Model: Stinger – C1		Date: 15-Oct-99	No.: MA250001
Modified Article: Weak Vertical Transport		Prepared by: K. Miura	
From: Technical Service Dept., GTS Division			
Reason for Modification:	☐ Parts catalog correction ☐ To facilitate assembly ☐ Part standardization	☐ Vendor change ☒ To improve reliability ☐ Other	☐ To meet standards ()

Model: Stinger – C1

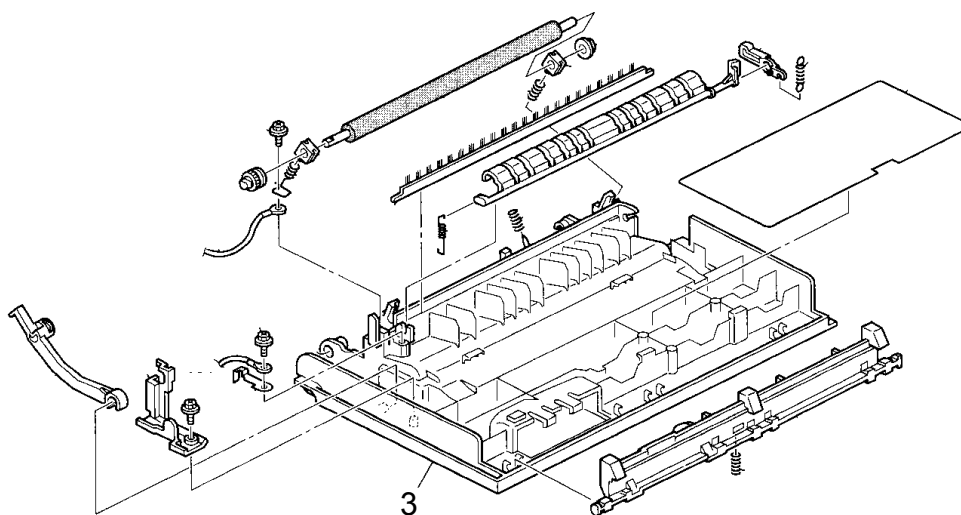
The right door has been modified to prevent the registration frame from becoming damaged when stress is applied. Specifically, a cutout has been added to the door near the hinge area so that stress will be evenly distributed throughout the cover (i.e. not transferred to the frame). Excessive stress will cause the cover to break or detach, preventing any damage to the frame.

Old part number	New part number	Description	Q'ty	Int	Page	Index	Note
A2501264	A2501279	Right Door	1	X/O	33	3

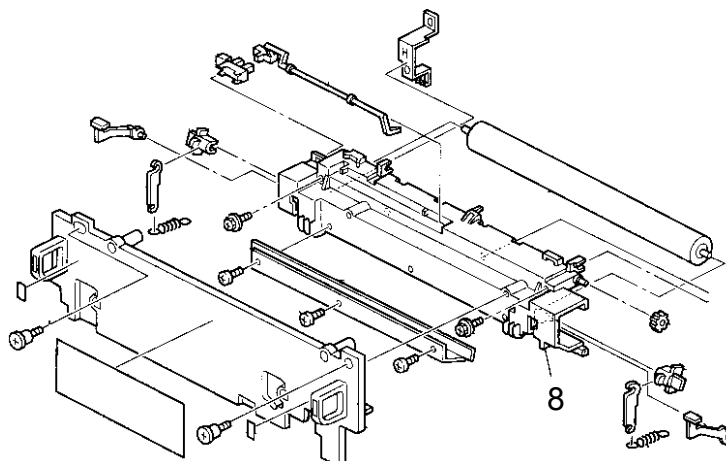
To ensure that paper is properly fed through the paper exit rollers, two ribs have been added to the pressure roller case. This will help to prevent accordion jams at the paper exit.

Old part number	New part number	Description	Q'ty	Int	Page	Index	Note
A2504105	A2504106	Pressure Roller Case	1	X/O	21	8

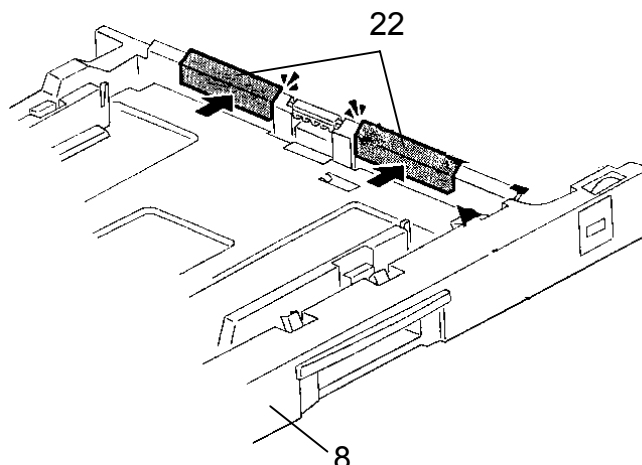
Two strips of mylar have been added to the paper feed tray to further ensure that the paper is properly fed. For details, see RTB #RA250026.

Old part number	New part number	Description	Q'ty	Int	Page	Index	Note
	A2502831	Mylar – Paper Feed	2		27	22	
A2502830	A2502850	Paper Tray	1	X/O	27	8

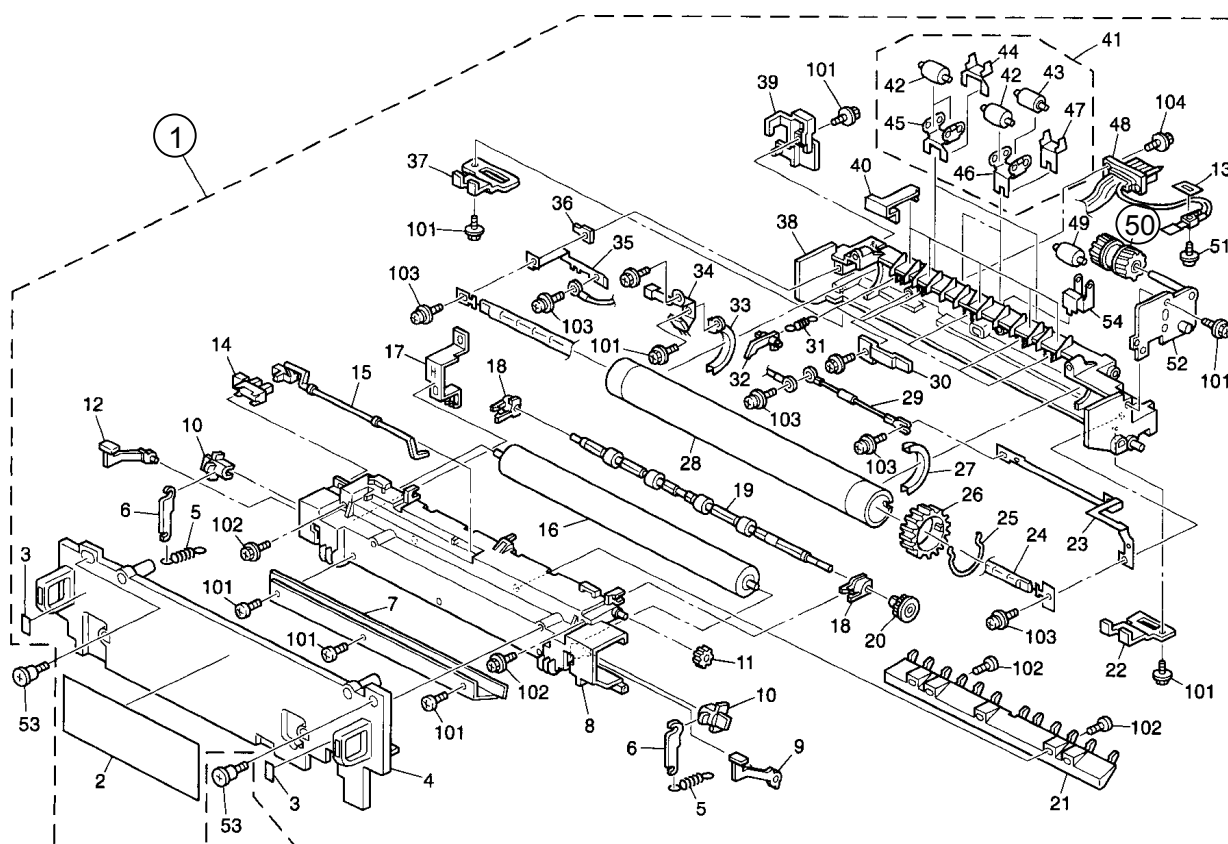
Although warned against in the operating instructions, some operators forcibly remove jammed paper from the fusing unit without using the pressure release lever. Since this can cause the Exit Roller Spring Plates to deform, the following parts have been changed to allow the Idler Gear to turn freely, even when the operator forgets to release the lever.

Old part number	New part number	Description	Q'ty	Int	Page	Index	Note
A2504018	A2504019	Fusing Unit - 120V	1	O/O	21	1	
A2504028	A2504029	Fusing Unit - 230V	1	O/O	21	1	
A2504037	A2504038	Fusing Unit - 230V for China	1	O/O	21	1	
G0294131	A2504132	Idler Gear - Fusing	1	O/O	21	50

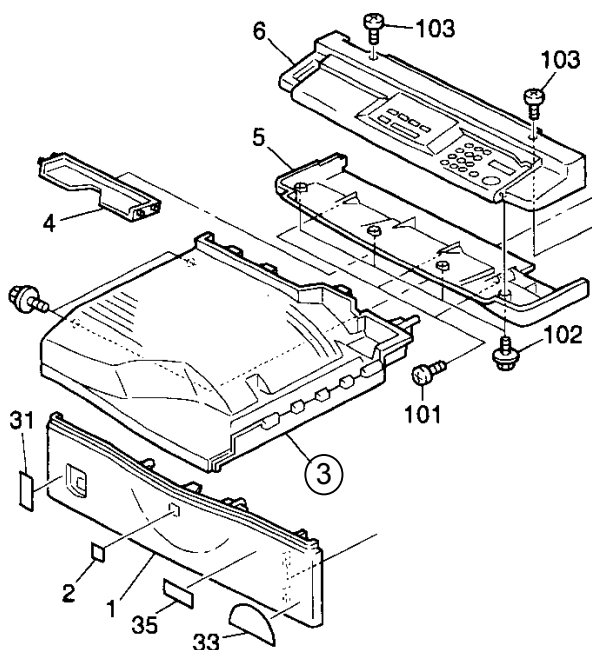
MB #MA250031 announced a modification applied to the mainframe Exit Cover to ensure the proper clearance between the mainframe Exit Cover and 1-bin Tray Junction Gate, as one solution to accordion jams (also see RTB RA250028 for details).

Old part number	New part number	Description	Q'ty	Int	Page	Index	Note
A2501281	A2501327	Exit Cover	1	X/O	7	3	
A2501325	A2501327	Exit Cover	1	X/O	7	3

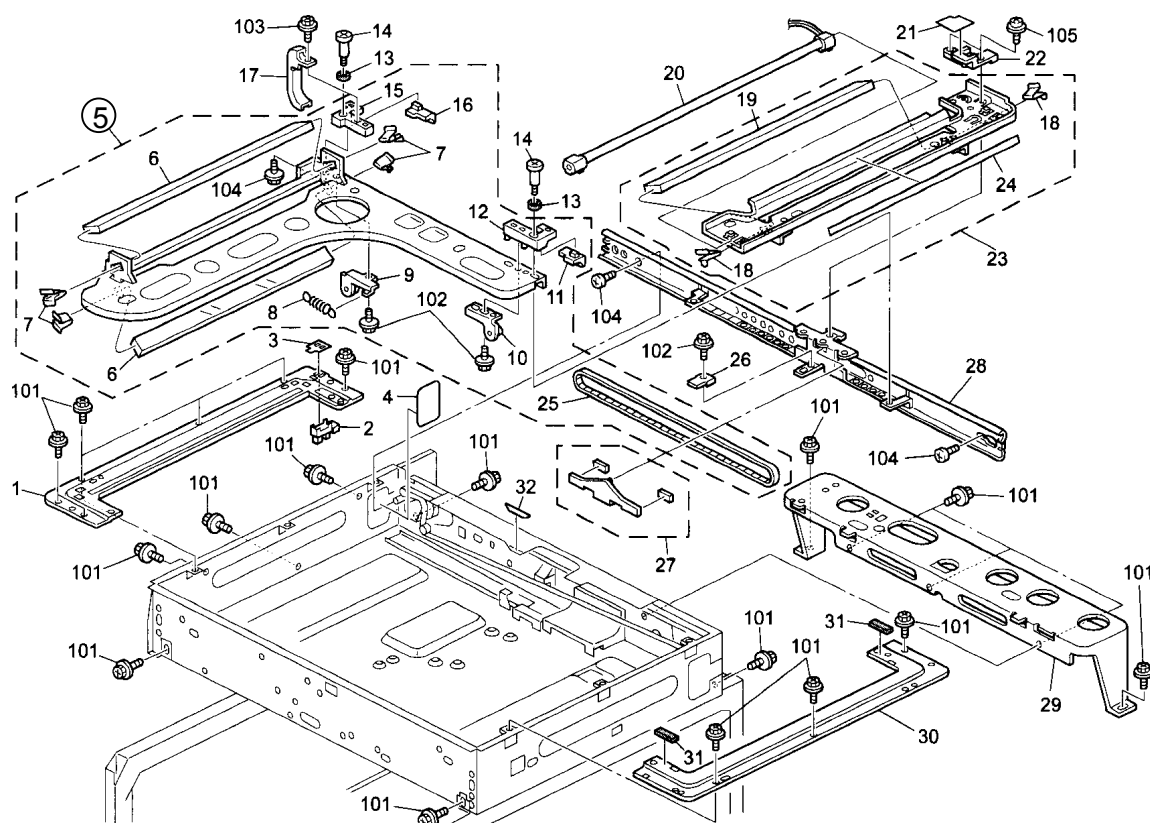
The following has been modified to maximize the accuracy of enlargement/reduction and straight-line writing:

Old part number	New part number	Description	Q'ty	Int	Page	Index	Note
A2501713	B0601713	2nd Mirror Carriage	1	X/O	15	5

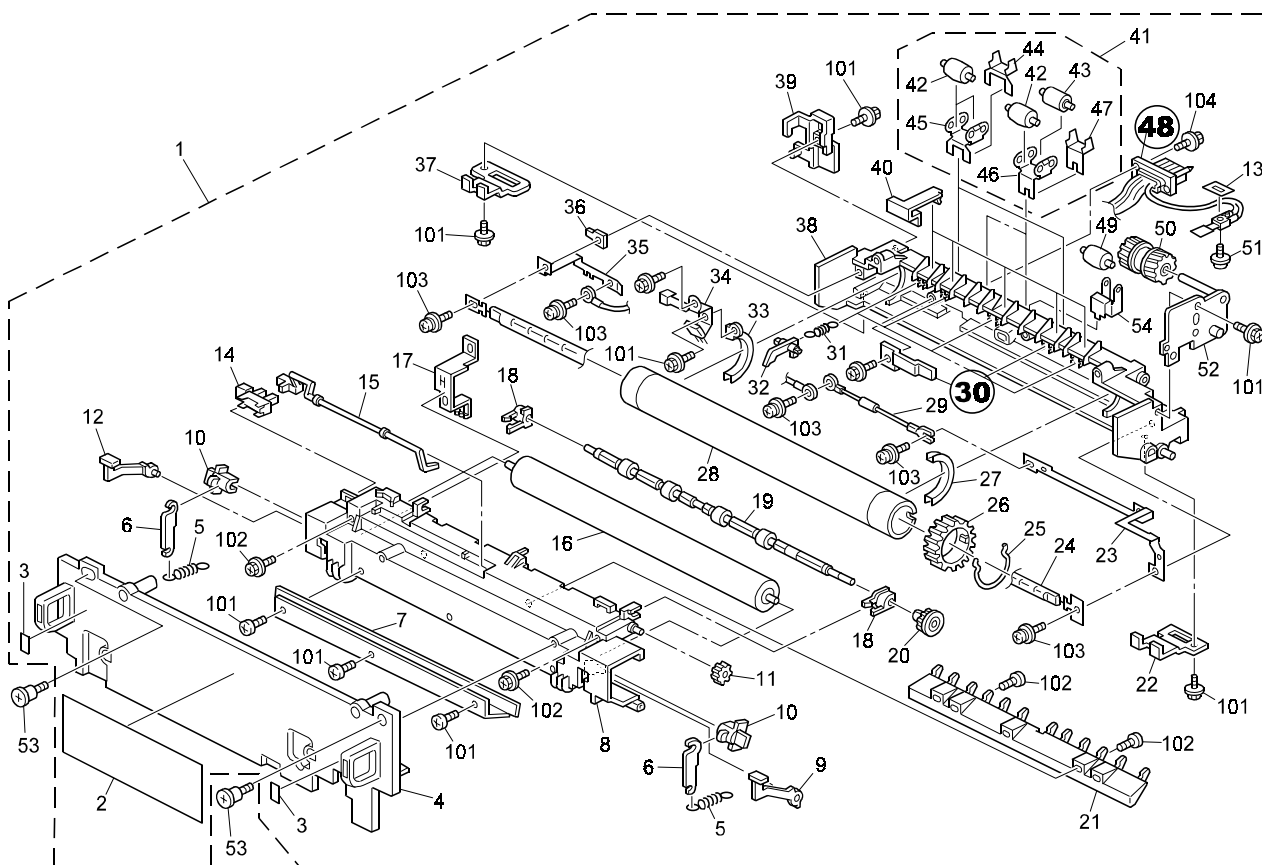
To ensure that slight deformations do not develop in the Fusing Harness Cover, the following parts have been modified.

Old part number	New part number	Description	Q'ty	Int	Page	Index	Note
A2504197	B0604197	Fusing Unit Connector - 230V	1	X/X	21	48	*1
G0294138	G0294125	Fusing Harness Cover	1	X/X	21	30	*1

*1: The Fusing Unit Connector and Fusing Harness Cover must be replaced together as a set.

Model: Stinger-C1	Date: 19-Dec-02	No.: MA250052
-------------------	-----------------	---------------

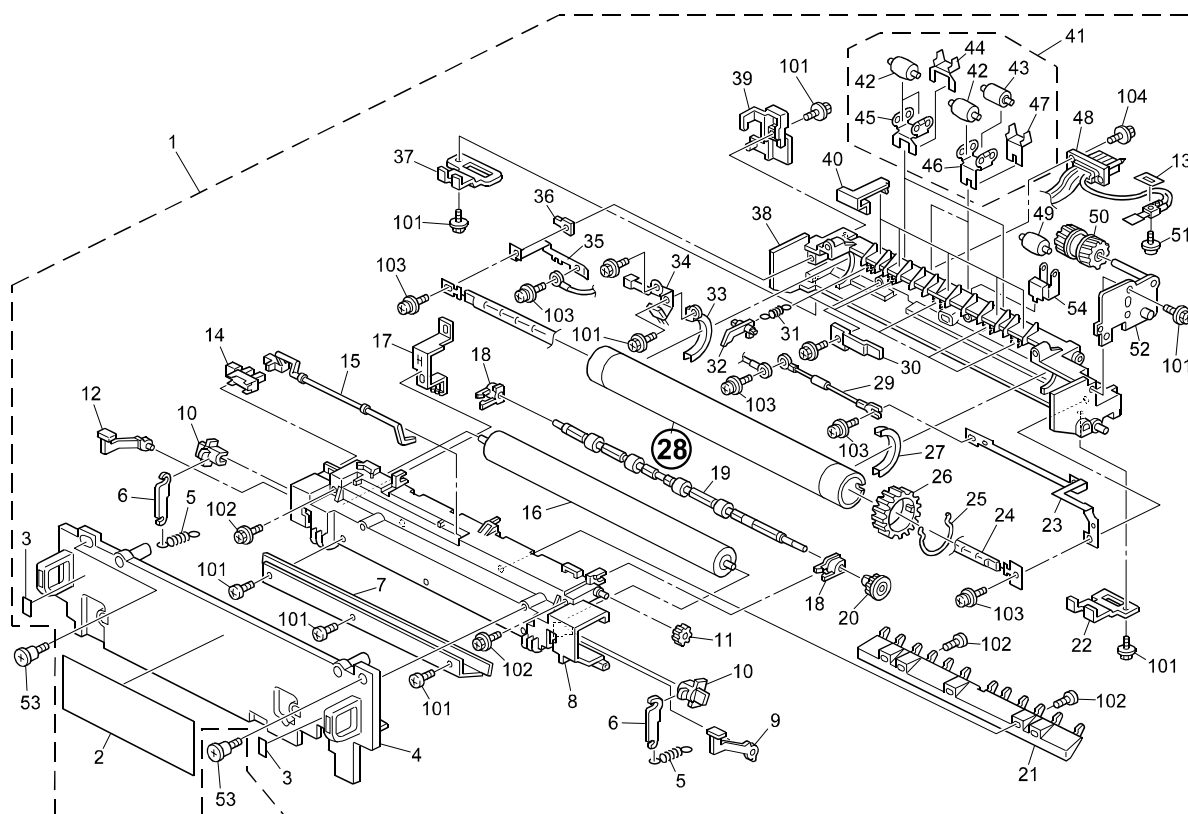
To provide extra latitude against grease being mistakenly applied to the hot roller bushings, the shape of the U-shaped ditch has been changed to increase its durability. This is because if grease is mistakenly applied to the bushings, this can create increased friction between the bushings and hot roller shaft, resulting in a large amount of stress along the U-shaped ditch.

Old part number	New part number	Description	Q'ty	Int	Page	Index	Note
A2504110	A2504111	Hot Roller	1	X/O	21	28
